APPENDIX B: ACCESS COMPLIANCE SURVEY REPORT OF FACILITIES

The City of Madera

Access Compliance Survey Report

Vending Machine

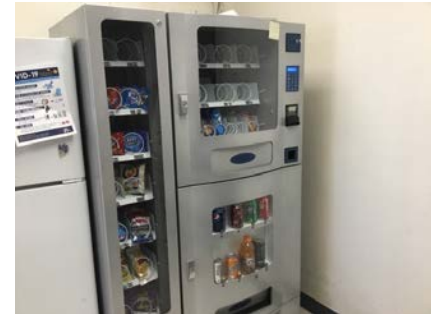
- *As-Built Description:*
Vending machine coin slot or dispensing outlet, more than 48" above the floor.
- *As-Built:* **11.5" to bottom of the dispenser tray and 60.5" to top buttons**
- *Proposed Solution:*
Advise vendor/leasing company to provide accessible vending machine with highest operable part at 48" max.

Door Threshold

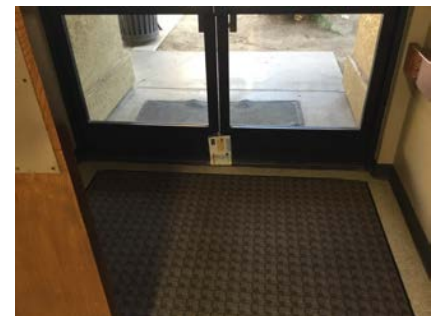
- 332
- *As-Built Description:*
Door inaccessible due to threshold or step at door exceeding 1/2".
 - *As-Built:* **1.2"**
 - *Proposed Solution:*
Modify threshold.

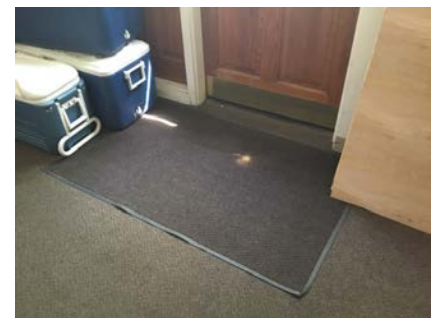
Doormat not securely attached to ground or floor structure.

• *Proposed Solution:*

Locker Facilities

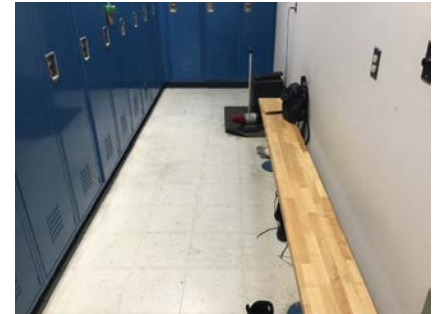
1437 • *As-Built Description:*
No section of bench provided adjacent to designated accessible locker, measuring minimum 20-24" deep, 48" wide, and 17-19" high, and fixed to a wall along the longer dimension.

Door Threshold

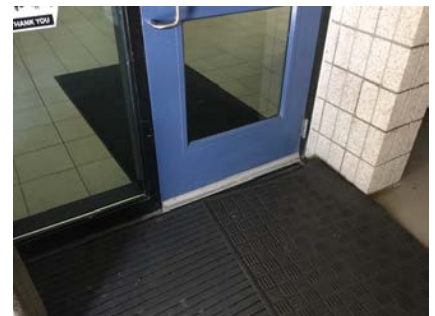
- 1519
- *As-Built Description:*
Door inaccessible due to threshold or step at door exceeding 1/2".
 - *As-Built:* **1.0"**
 - *Proposed Solution:*
Modify threshold to be no more than 1/2" by removing existing paving at door and providing landing with edge ramping (slope 1:20 max).

Signage

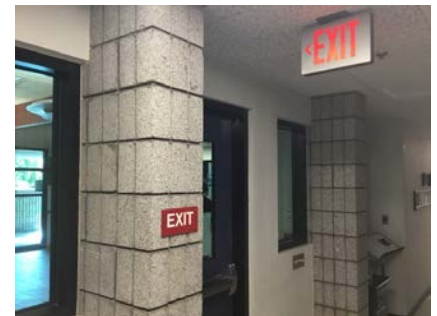
1495 • *As-Built Description:*
 Sign not located on latch side of door and/or not located at 48" min. above to baseline of the lowest Braille cells and 60" max. to baseline of the highest line of raised characters.
 • *As-Built:* **Wrong side.**
 • *Proposed Solution:*
 Provide compliant signage including tactile characters and Grade II Braille on latch side of door located at compliant height.

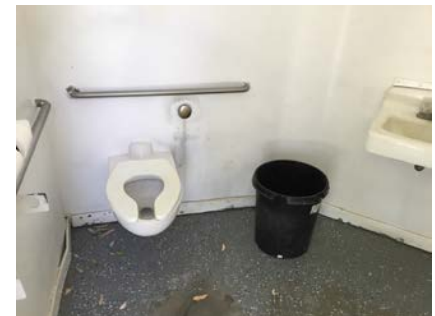
1949 • *As-Built Description:*
60" min. clearance around a water closet measured perpendicular from the side wall not provided (Fixtures are not allowed to overlap this clearance).

• *As-Built: 57.5" to lavatory*

• *Proposed Solution:*
Relocate adjacent fixture and remodel restroom as needed.

Signage

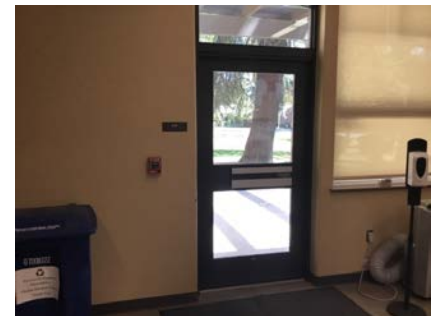
1003 • *As-Built Description:*
 Sign not located on latch side of door and/or not located at 48" min. above to baseline of the lowest Braille cells and 60" max. to baseline of the highest line of raised characters.

• *As-Built:* **Wrong side**

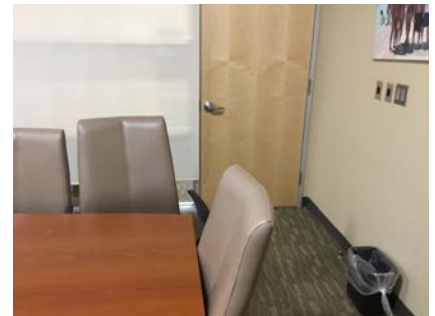
- 1014
- *As-Built Description:*
Front approach: At pull side, door does not have clear and level maneuvering space measuring door width plus 18" x 60". (24" x 60" at exterior doors).
 - *Proposed Solution:*
Remove or relocate furniture or storage items.

Disabled Seating

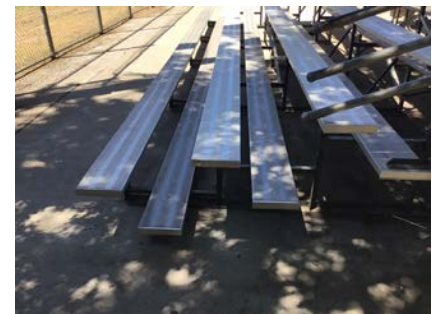
1584 • *As-Built Description:*
Aisle transfer seats not provided (1% of total fixed seats, but not less than 1).

• *Proposed Solution:*
Provide aisle transfer seats without armrests on the aisle side, or removable or folding armrests on the aisle seat. Include sign or marker identifying such seats. (NOTE: Space must be adjacent to regular seating; can provide easily removable fixed seat).

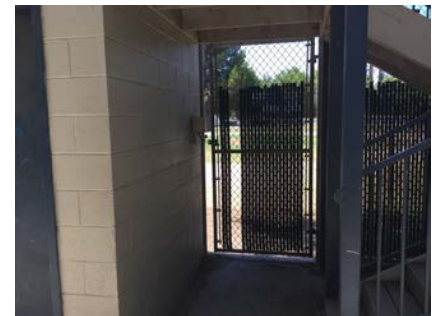
The shelves are also in the door maneuvering clearance.

- 1579
- *As-Built Description:*
Protruding objects more than 4" from wall, when bottom of object more than 27" or less than 80" above finished floor.
 - *As-Built:* **6.0" at 56.0" high**
 - *Proposed Solution:*
Remove/relocate protruding object. Patch existing surface.
 - *Notes:*

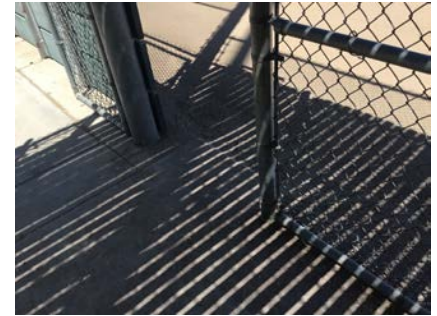
• *As-Built:* **1.0" at dugouts.**

• *Proposed Solution:*
Remove, replace or repair area of pavement sufficient to correct abrupt change in level.

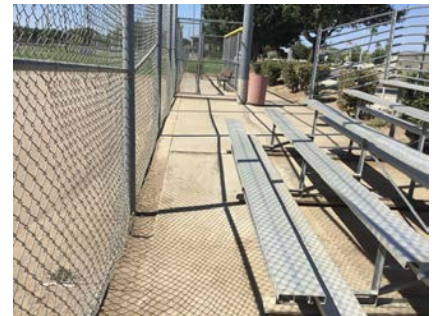
- 1659
- *As-Built Description:*
Walk: Pavement dislocation creates abrupt change in level exceeding 1/2" in accessible route.
 - *As-Built:* **2.0"**
 - *Proposed Solution:*
Remove, replace or repair area of pavement sufficient to correct abrupt change in level.

Vertical Clearance

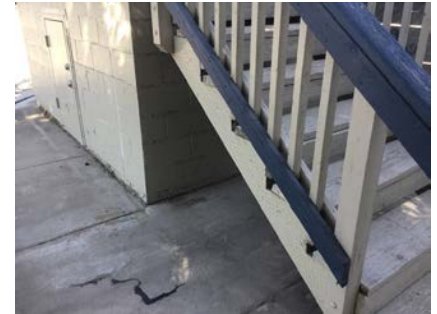
1692 • *As-Built Description:*
Overhead clearance less than 80" above finished floor.
• *As-Built:* **27.0' to 59.0' high**
• *Proposed Solution:*
Provide cane-detectable railing to mark area of low clearance.

Cross Slope

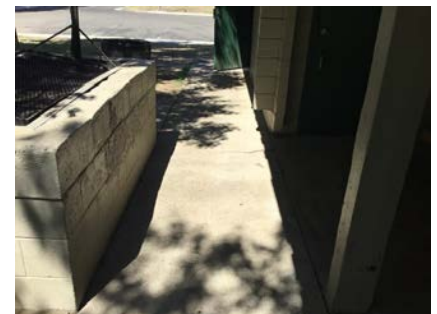
1556 • *As-Built Description:*
Cross slope more than 1":48" (2.083%).

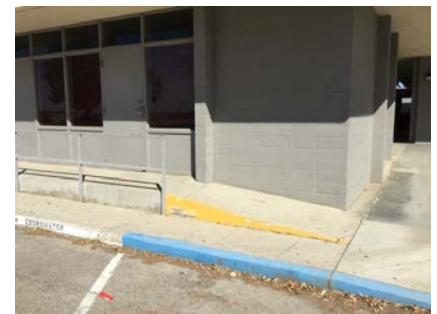
The ramps have a rise of 10.5"

Door

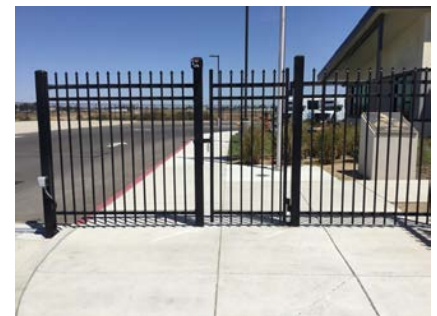
- 2128
- *As-Built Description:*
At push side of door on accessible route, bottom 10" does not have a smooth, uninterrupted surface.
 - *Proposed Solution:*
Provide 10" min. "kick plate" covering width of door when altering area.

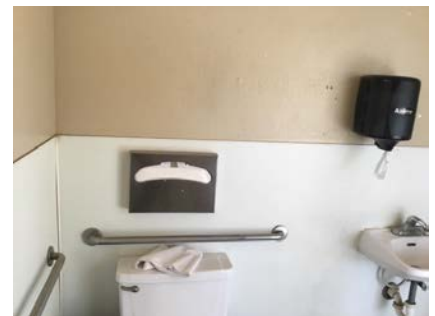
This element complies with Safe Harbor if altered or constructed before March 15, 2012. The dimensional requirements in this CBC citation applied from the 2010 CBC to the code cycle at the time of this survey.

- 1224
- *As-Built Description:*
60" min. clearance around a water closet measured perpendicular from the side wall not provided (Fixtures are not allowed to overlap this clearance).
 - *As-Built:* **54.0"**
 - *Proposed Solution:*
Remove adjacent fixture and provide new enclosure at accessible water closet.
 - **Notes:**

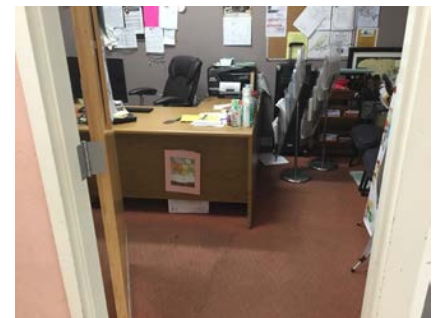
- 1308
- *As-Built Description:*
Front approach: At pull side, door does not have clear and level maneuvering space measuring door width plus 18" x 60". (24" x 60" at exterior doors).
 - *As-Built:* **55.0"**
 - *Proposed Solution:*
Remove or relocate furniture or storage items.

Top and Bottom Extension at

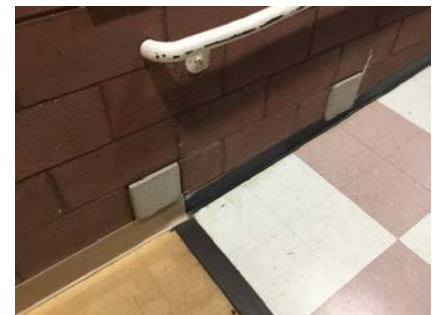
1347 • *As-Built Description:*
 Ramp handrail does not extend horizontally 12" past top and / or bottom of ramp.
 • *Proposed Solution:*
 Provide ramp handrail extension (cost for each extension piece).
